Subject: CERTIFICATE OF COMPLIANCE NO. 9292 FOR THE MODEL NO. PATRIOT PACKAGE: SUBMISSION of Response to Request for Additional Information (RAI) – DOCKET No. 71-9292; TAC No. L23770

Enclosure 1: RAI Questions and Westinghouse Responses

PATRIOT

SAR Table 6A-11

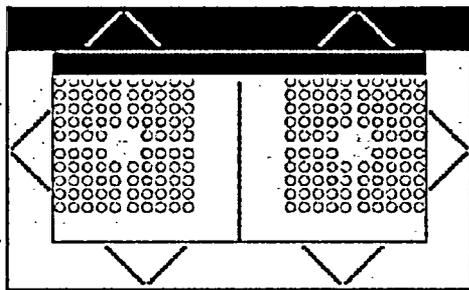
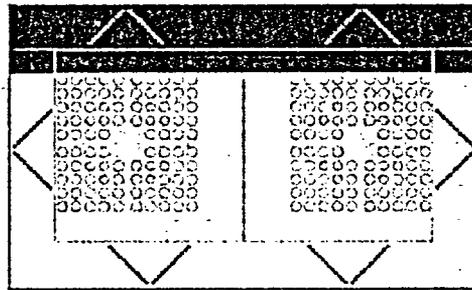
Justify the partial flooding configuration in the criticality analysis as the most reactive configuration of internal moderation.

Verify that the chosen partial flooding configuration is the most reactive, providing information in the RAI response that shows this and revising the FSAR criticality as needed.

The exact nature of this question had to do with the fact that the partial flooding configuration, shown in figure 6A-11 of the SAR and below, shows that there is water in the outer portion of the inner container that extends above the fuel assemblies. The NRC raised the question about the effect on k_{eff} of replacing that water with void.

Westinghouse took the most limiting case in the SAR and modified the input deck to add void to that area. The most limiting case corresponds to Run #6P-1-030 in table 6A-6. The results are given in the table below. They show that adding the void to that area results in a very slight increase in k_{eff} , still below the USL of 0.9343.

Run #	k_{eff}
6P-1-030	0.9285±0.0007
6P-1-030 with void at edge	0.9308±0.0007

The following paragraph was added to section 6A.6.1.

Figure 6A-4 Typical 10x10 Assembly Design

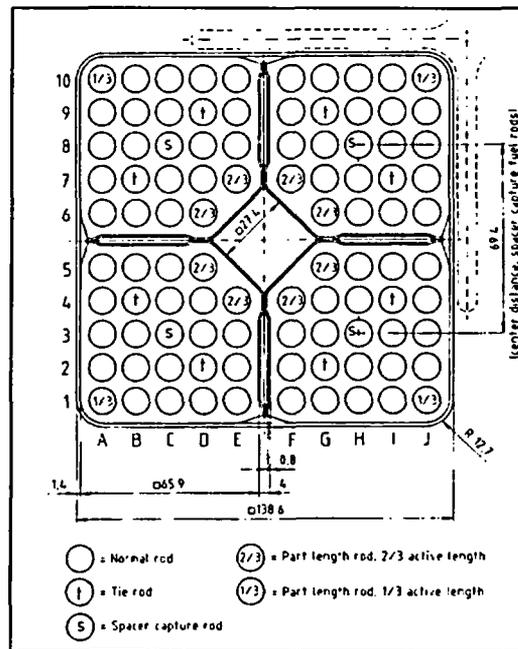
Specify whether the fuel loadings contain partial length fuel rods or Gadolinia-Urania rods and the maximum number of each.

Describe in the proposed FSAR how fuel loading modeling was conservatively conducted to address partial loading.

The contents for which section 6A has been added to the SAR is a fuel bundle that contains twelve (12) partial length rods. Revision 1 to the SAR will revise Section 1.2.3, *Contents of Packaging*, to describe the new fuel bundle. An explanation follows.

The fuel bundle shown in figure 6A-4 contains four-1/3 length rods and eight-2/3 length rods. The 1/3 length rods are located on the outside corners of the bundle. The eight-2/3 length rods, two per mini-bundle, are located on the geometric diagonal toward the center of the bundle. The three new loading sets, #4 - #6, correspond to the upper, middle, and lower zones of the fuel bundle respectively. The criticality safety analysis was performed by analyzing each zone of the contents in its most conservative configuration as though it were a full length fuel bundle, thus bounding the actual fuel bundle.

The second assembly type, shown in figure 6A-4, is made up of four sub-assemblies with 24 rods in each sub-assembly. The assembly contains four-1/3 length rods and eight-2/3 length rods. The 1/3 length rods are located on the outside corners of the assembly. The eight-2/3 length rods, two per sub-assembly, are located on the geometric diagonal toward the center of the assembly. The three zones (upper, middle, and lower) of the assembly correspond to the fuel loading sets #4-#6 discussed in Section 6A.
